## DESIGN COMMISSION REGULAR MEETING AGENDA

# Design Commission Design Review

<b>Project No:</b>	DSR18-004
<b>Brief Description:</b>	Study Session
<b>Location:</b>	2856 80 <sup>th</sup> Ave SE Mercer Island WA 98040; Identified by King County Tax Parcel #5452300540
<b>Applicant:</b>	Scot Carr, PUBLIC47 Architects
<b>Staff Contact:</b>	Robin Proebsting, Senior Planner

Mercer Island Design Commission Study Session  
November 14, 2018

EAST ELEVATION - 78TH AVENUE

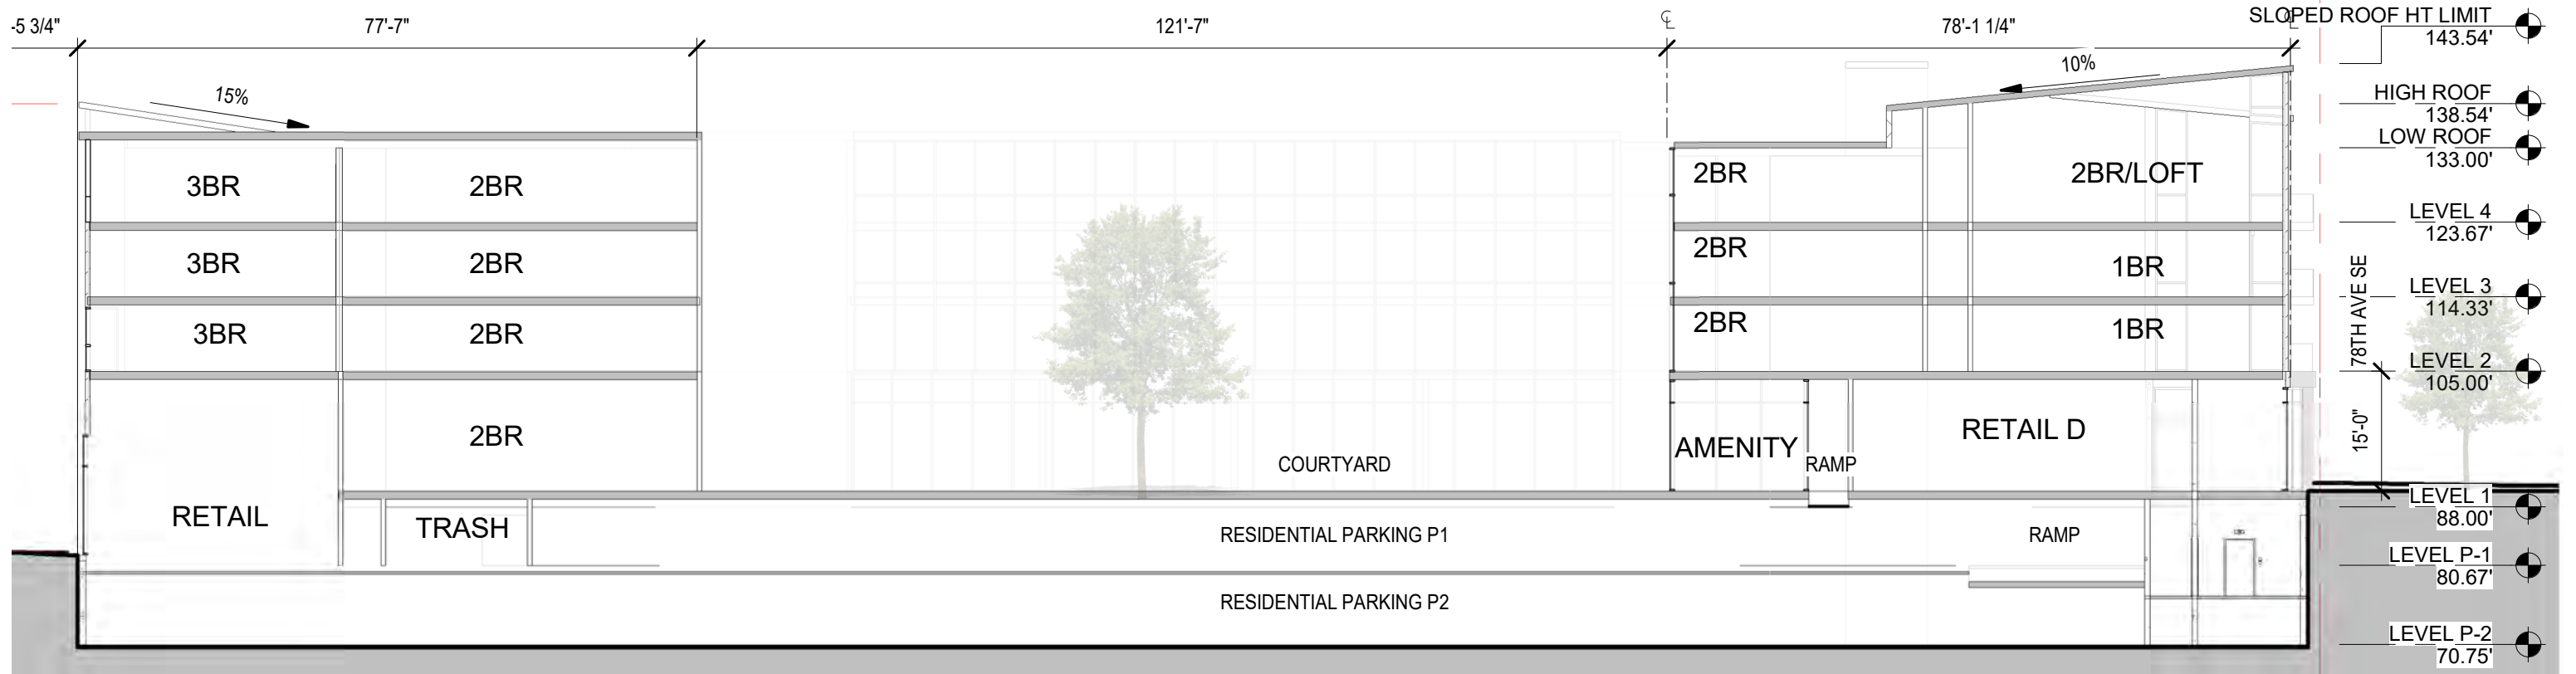
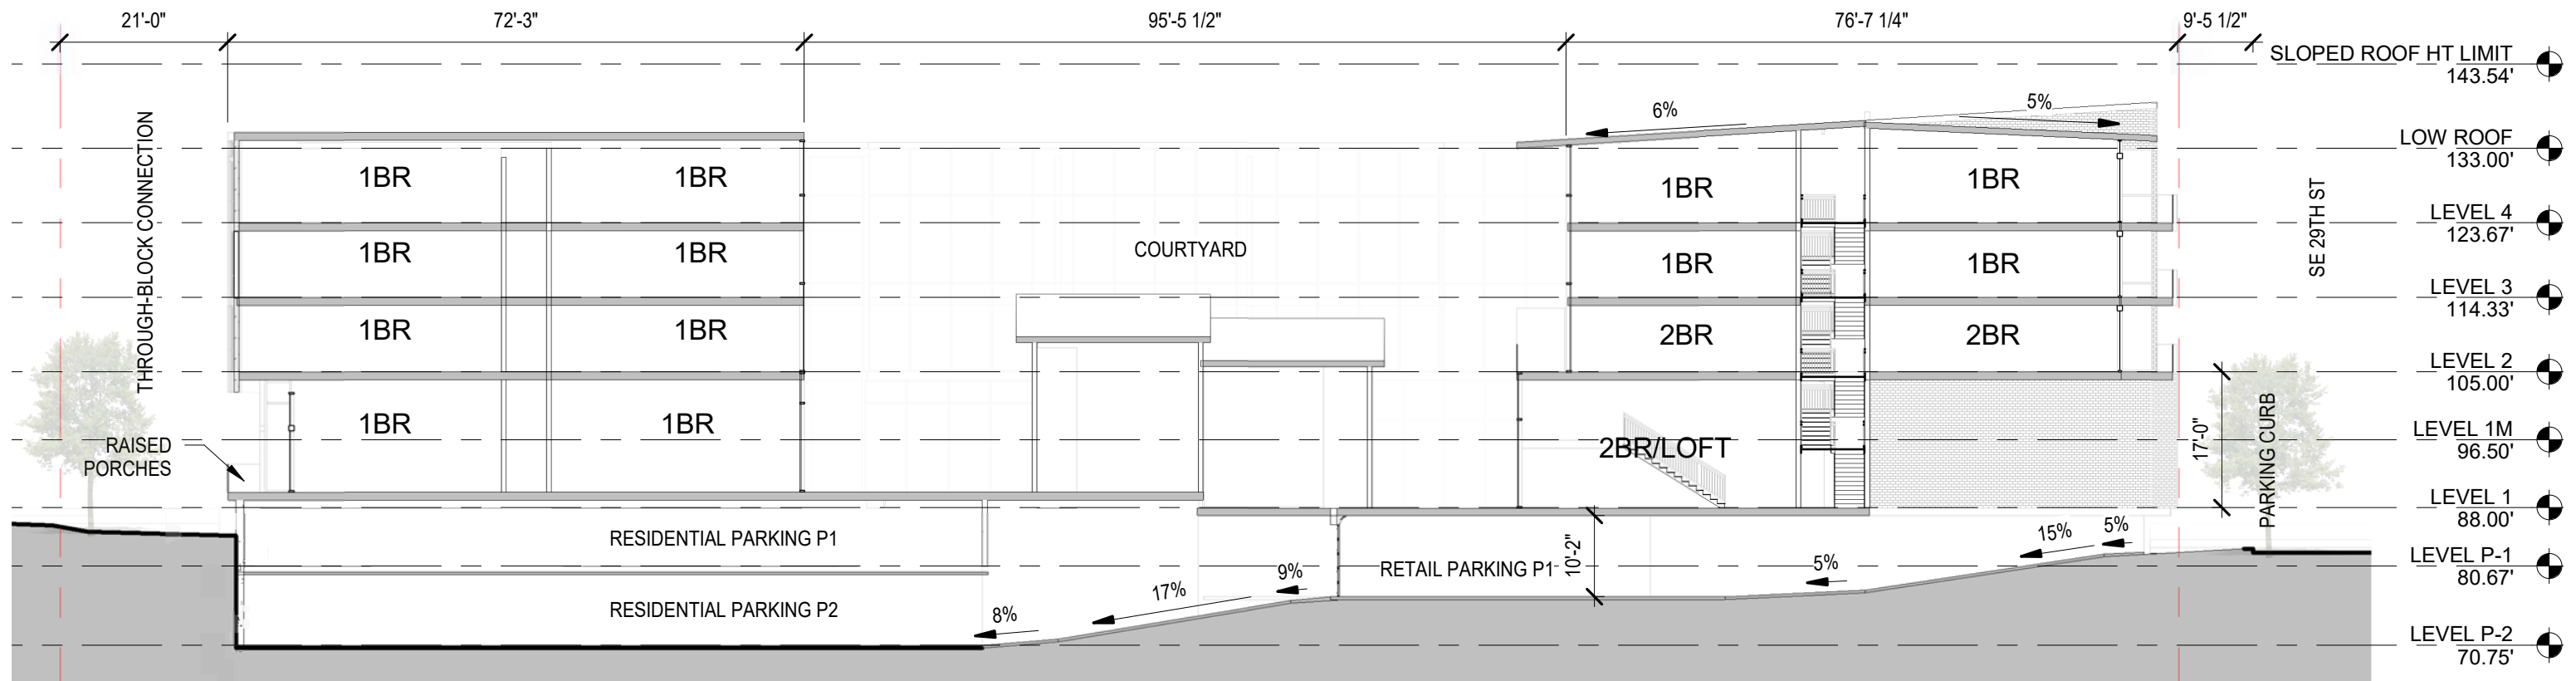
The Town Center Code requires two types of modulation; major façade modulation and minor façade modulation. Major façade modulation, as provided in MICC 19.11.100(B)(3), provides three options for modulation, the intent of which is to "...at intervals no greater than 120 feet to break up the massing of the block. The design commission may approve modifications or alternatives to the following features if the proposed modulation is at least as aesthetically acceptable as one of the following features..." In summary, the features are either (a) vertical building modulation at least 20 feet deep and 30 feet wide. For multi-story buildings, the modulation must extend through more than one-half of the building stories. (b) Use of a significant contrasting vertical modulated design component featuring an extension through all stories above the first story fronting on the street except for upper stories that are setback more than 10 feet from the façade, a change in building materials that create contrast, horizontal modulation from the façade by an average of 24 inches, or roofline modulation. (c) Building walls with contrasting articulation and roofline modulation that make it appear like two or more distinct buildings. The contrasting facades shall employ (i) different materials and or configuration of building materials, and (ii) contrasting window design.

All buildings are subject to minor façade modulation as provided in MICC 19.11.100(B)(4), "...to reduce the perceived scale of large buildings and add visual interest to facades..." "...At least three of the following features shall be employed at intervals no greater than 50 feet subject to design commission approval taking into account the nature of the development and the site:

***Do the graphics provided show adequate modulation?***

Option A: Seat Docks

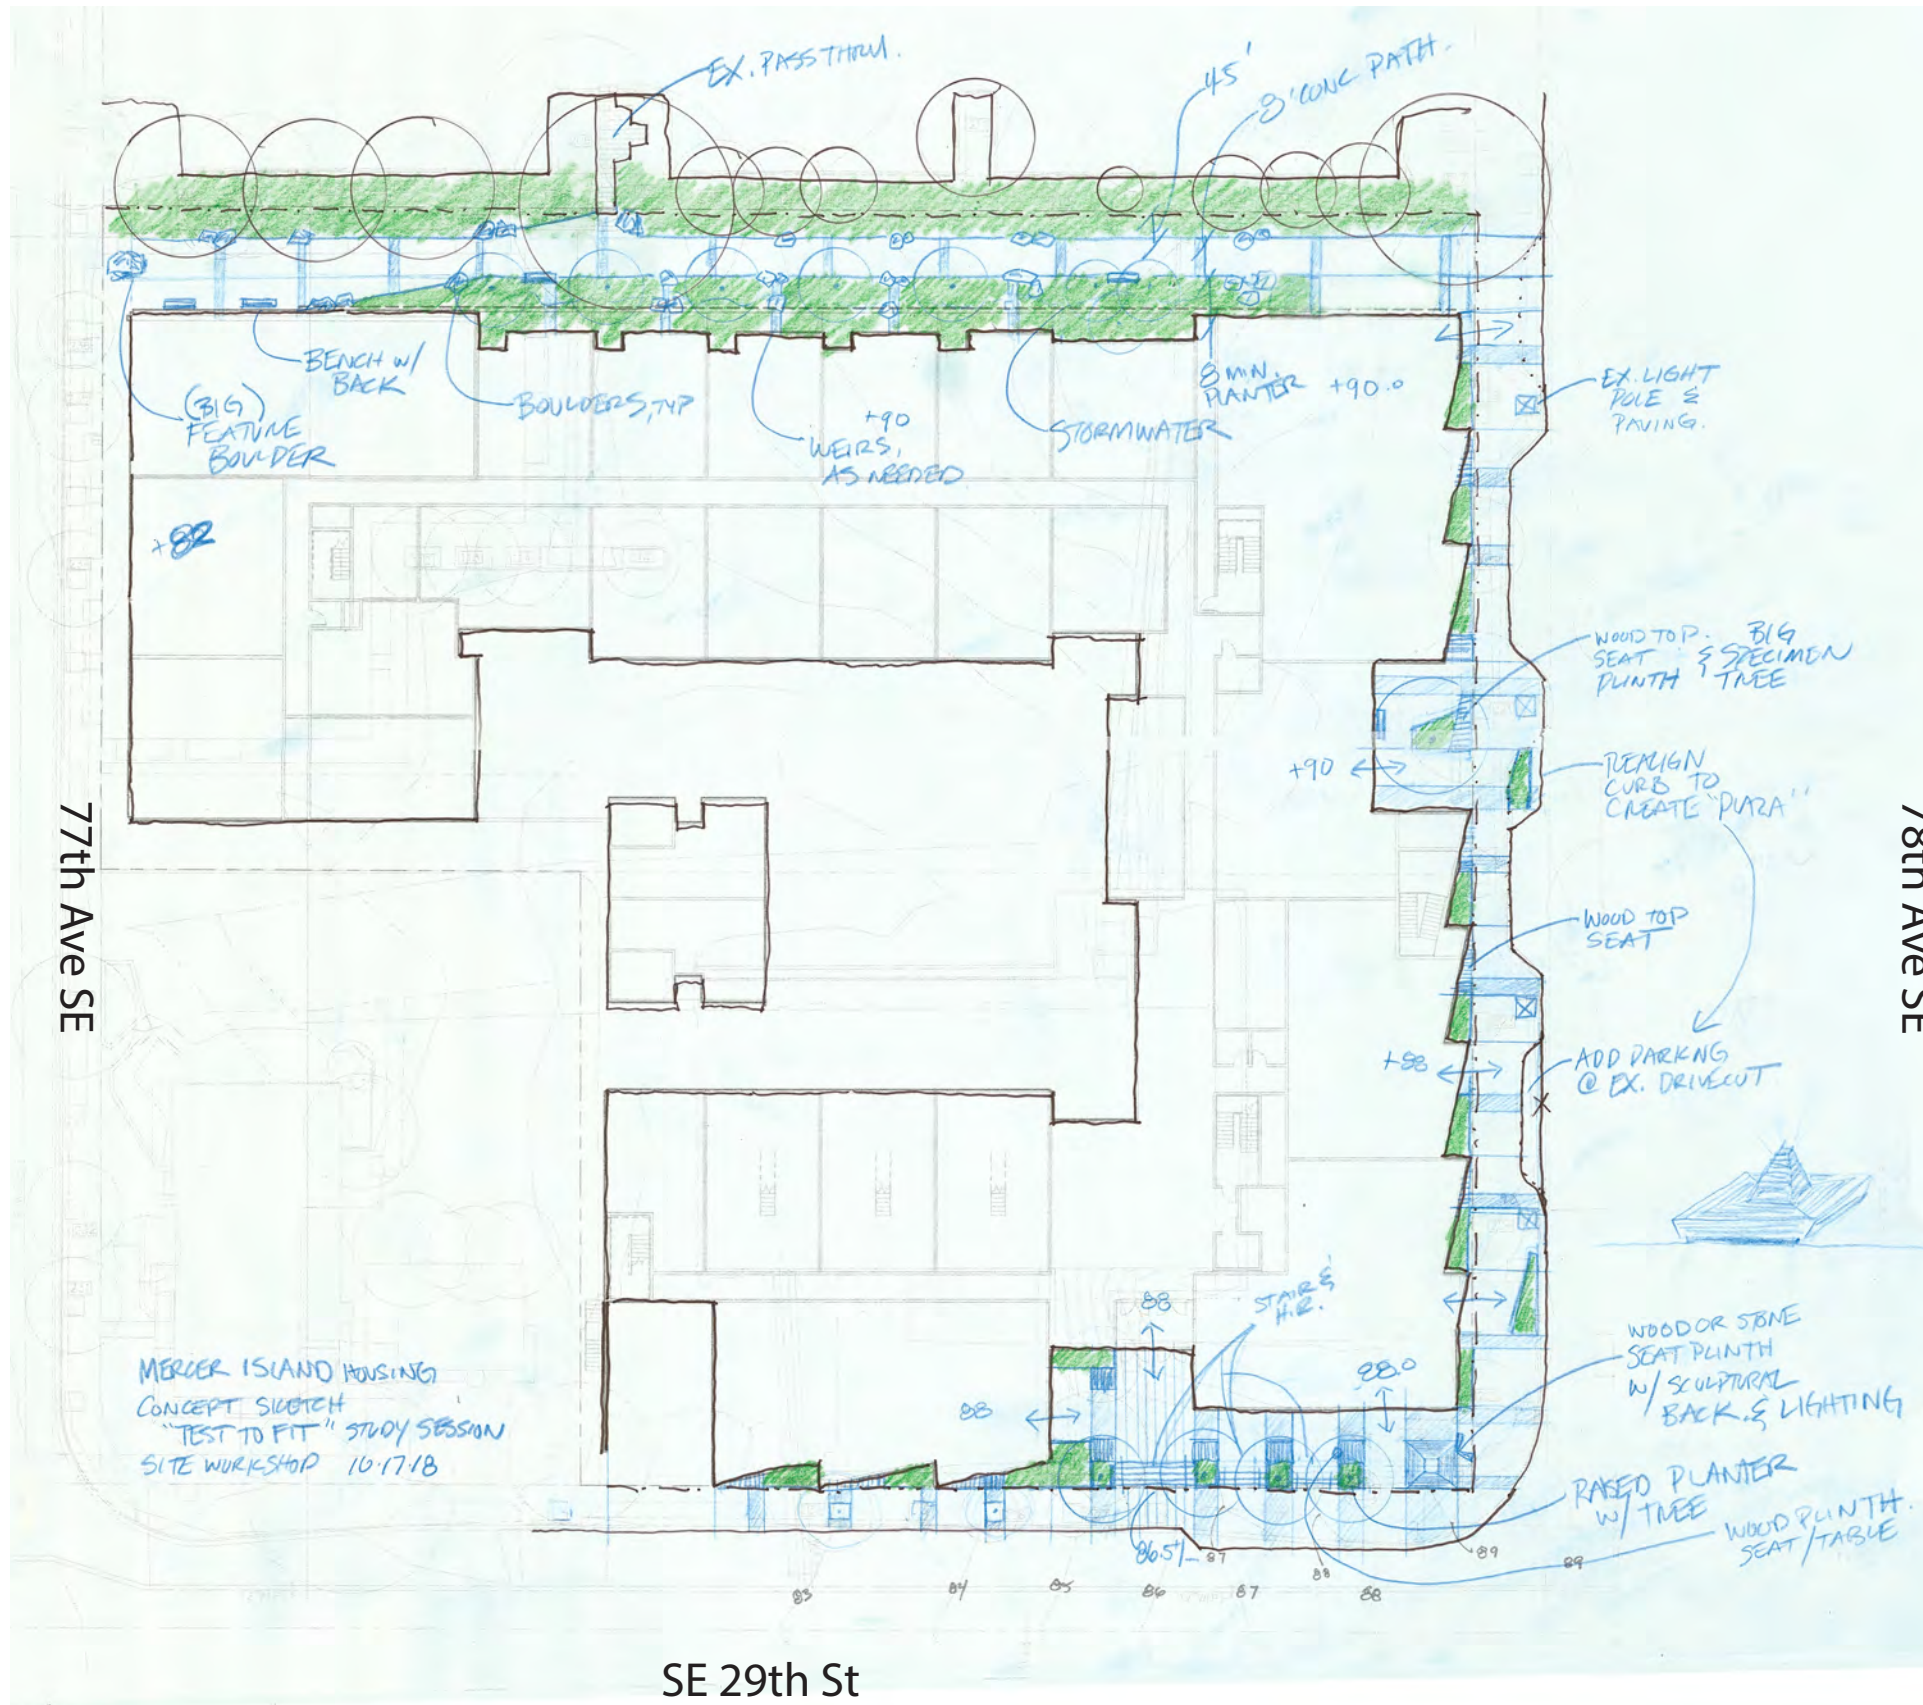
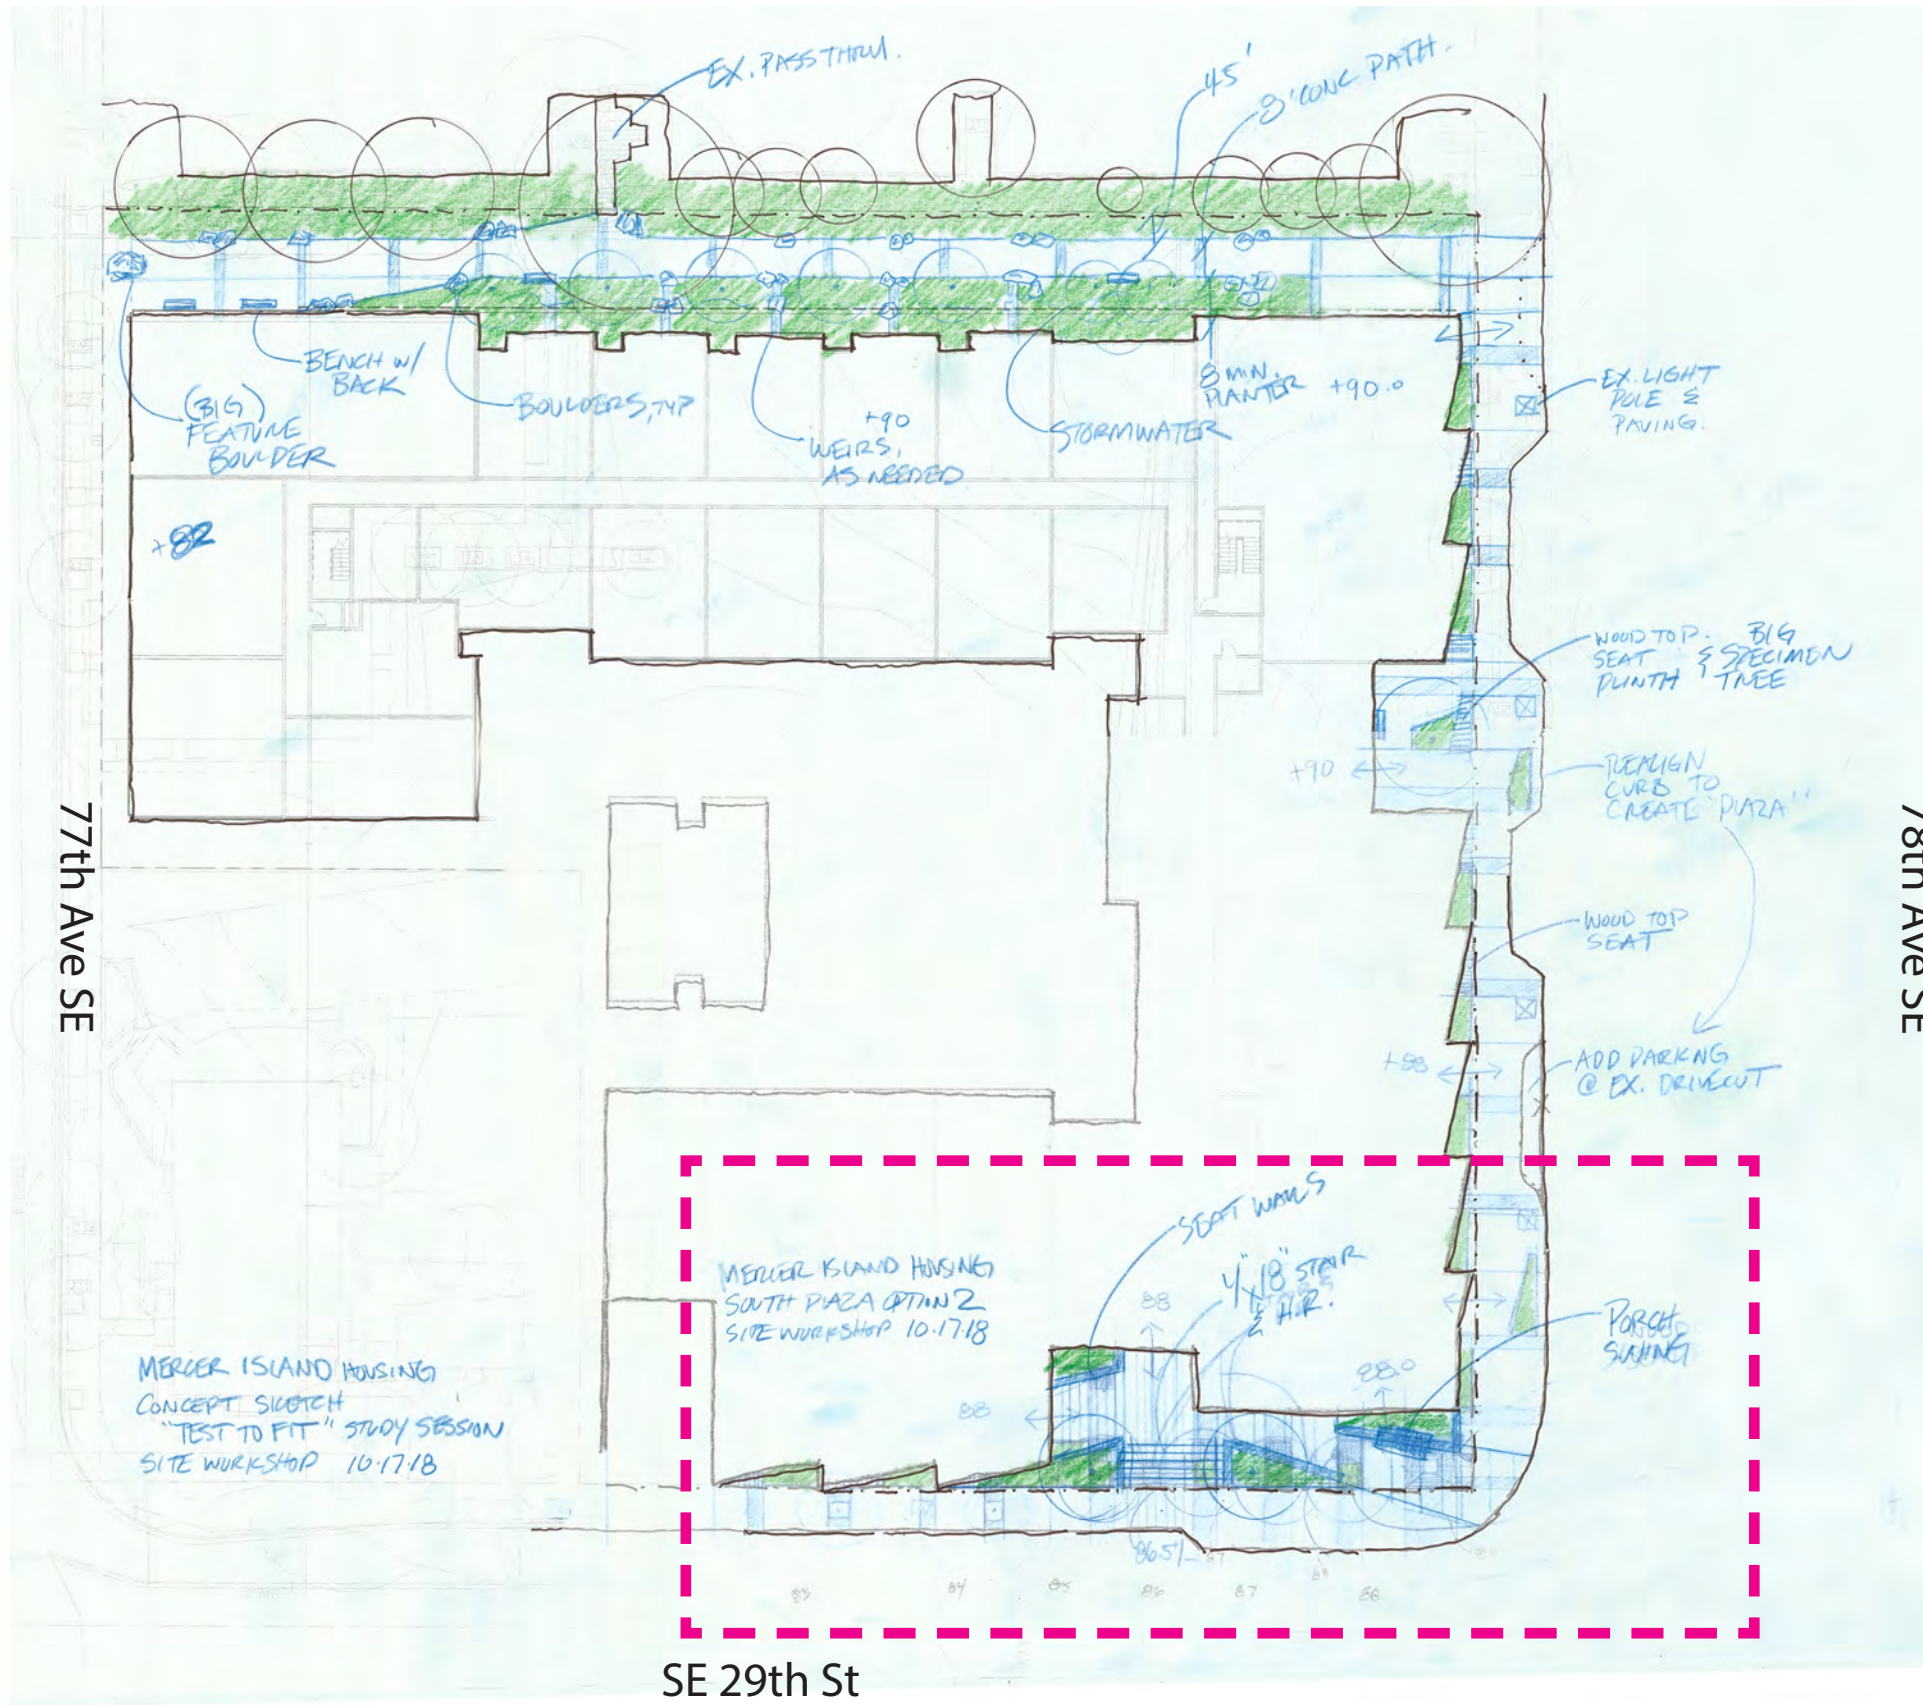
Options A and B shows identical landscaping and seating along 78<sup>th</sup> Avenue. Additional sidewalk setback is provided adjacent to the building modulation on 78<sup>th</sup> Avenue. Option A provides raised planters with wood plinth set/tables at the open space in the southwestern corner of the property. Option B provides seat walks and a porch swing at the open space in the southwestern corner of the property.

Options A and B both provide a through block connection and public open space. The through-block connection extends along the north property line. The public open space is provided at the southeast corner of the property. Pursuant to MICC 19.11.060(B)(1), the total area of the through block connection and the public open space must equal or exceed 3% of the gross floor area of the development. The gross floor area is not yet available so compliance with this section cannot be determined. The applicant will need to demonstrate compliance with their formal application.

### ***What types of decorative landmarks or kiosks or other site features should the applicant provide as minor or major site features?***
